## **SOUTHPORT INDUSTRIAL ESTATE SUBDIVISION,**

### **UNIT 1**

Engineering Comments: FINAL PLAT COMMENTS (should be addressed prior to submitting the FINAL PLAT for review and/or signature by the City Engineer):

# DETAIL SITE PLAN

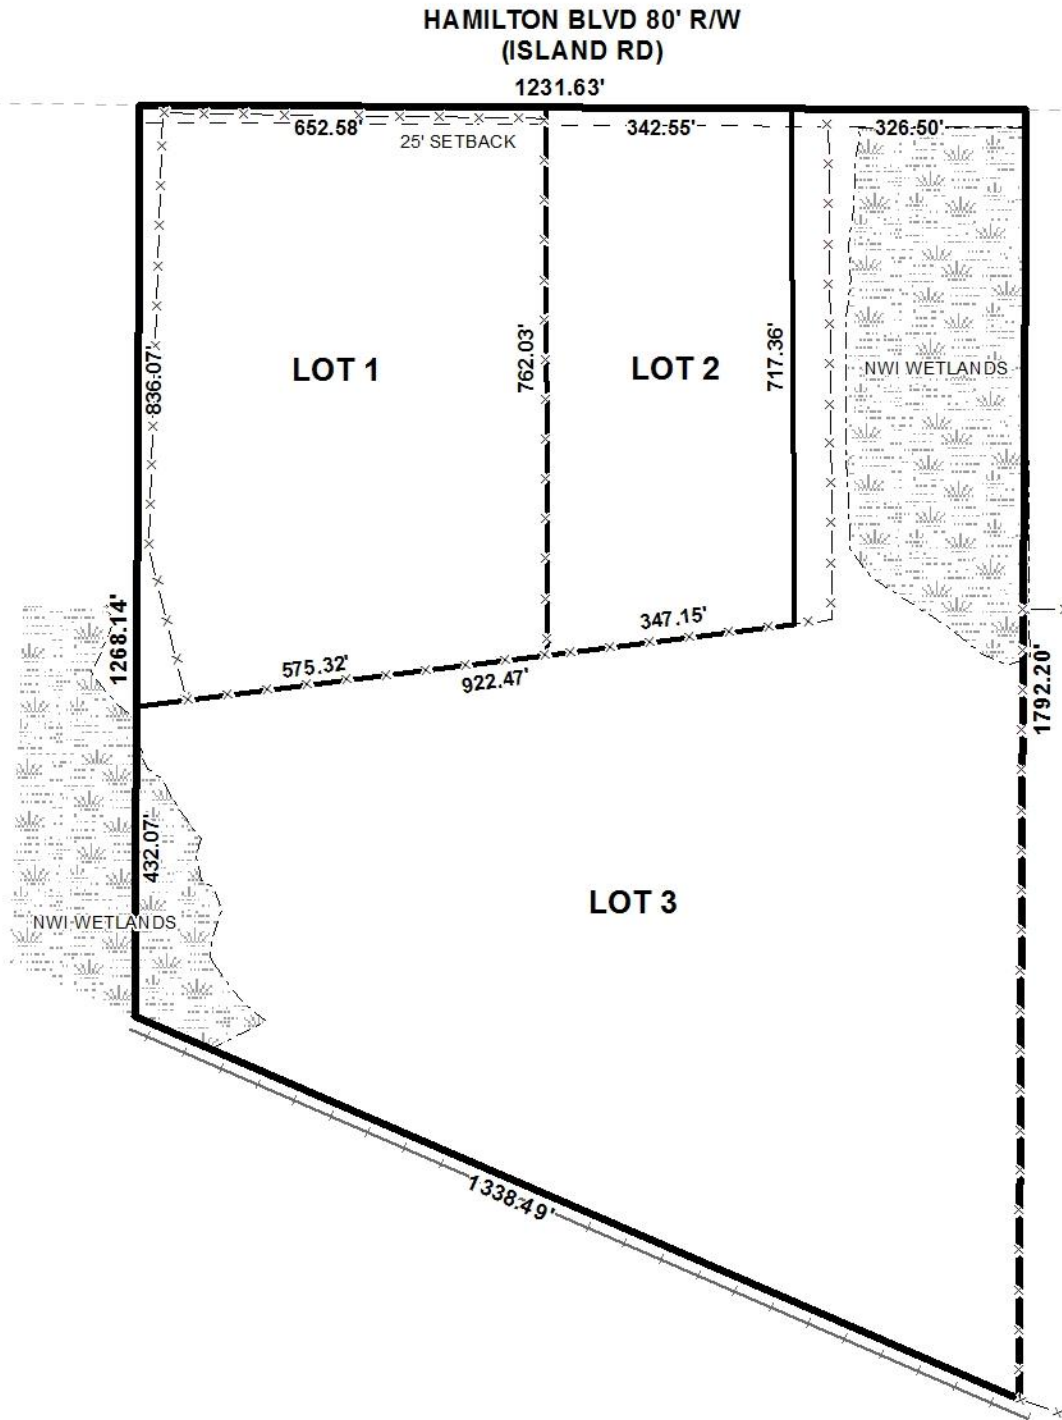
- B. Check/clarify that the existing RR track centerline is located within a 500 foot wide ROW but is shown and labeled to be 20 feet from the south property line.

- C. Show and label all flood zones. The 2010 FEMA FIRM shows both AE and X(S) flood zones on this property.
- D. Show and label the MFFE (Minimum Finished Floor Elevation) on each lot that contains an AE, V, or X (shaded) flood zone designation.

The lot fronts Hamilton Boulevard, a proposed major street, which should have a right-of-way of 100'. The preliminary plat illustrates an existing right-of-way width of 80', making dedication necessary to provide 50' from the centerline.

The 25' minimum building setback line is indicated along Hamilton Boulevard, and should be adjusted for dedication on the Final Plat, if approved.

As on the preliminary plat, the lot size labels should be retained in both square feet and acres on the Final Plat, or a table should be furnished on the Final Plat providing the same information, adjusted for dedication.

No easements are indicated on the preliminary plat. If any easements are recorded on the site they should be indicated and labeled on the Final Plat, and a note should be placed on the Final Plat stating that no structure may be placed or constructed within any easement.

It should be noted that the proposed Lots 1 and 2 have shared access. Therefore, if the Subdivision is approved, either the shared access between the lots either needs to be removed, or the site will require an approved Planned Unit Development prior to construction.

- 1) either removal of shared access between Lots 1 and 2, or approval of a Planned Unit Development, prior to construction on Lots 1 or 2;
- 2) dedication to provide 50' from the centerline of Hamilton Boulevard;

- 3) revision of the plat to illustrate the 25' minimum building setback line along Hamilton Boulevard, adjusted for dedication;
- 4) retention of the lot size in both square feet and acres, or the furnishing of a table on the Final Plat providing the same information, adjusted for dedication;

- 5) placement of a note on the Final Plat stating that no structure may be constructed or placed within any easement, if applicable;
- 6) compliance with the Engineering comments: *(FINAL PLAT COMMENTS (should be addressed prior to submitting the FINAL PLAT for review and/or signature by the City Engineer): A. Provide all of the required information on the SUBDIVISION PLAT (i.e. signature blocks, signatures, certification statements, written legal description, required notes, legend, scale, bearings and distances) that is required by the current Alabama State Board of Licensure for Professional Engineers and Land Surveyors. B. Check/clarify that the existing RR track centerline is located within a 500 foot wide ROW but is shown and labeled to be 20 feet from the south property line. C. Show and label all flood zones. The 2010 FEMA FIRM shows both AE and X(S) flood zones on this property. D. Show and label the MFFE (Minimum Finished Floor Elevation) on each*
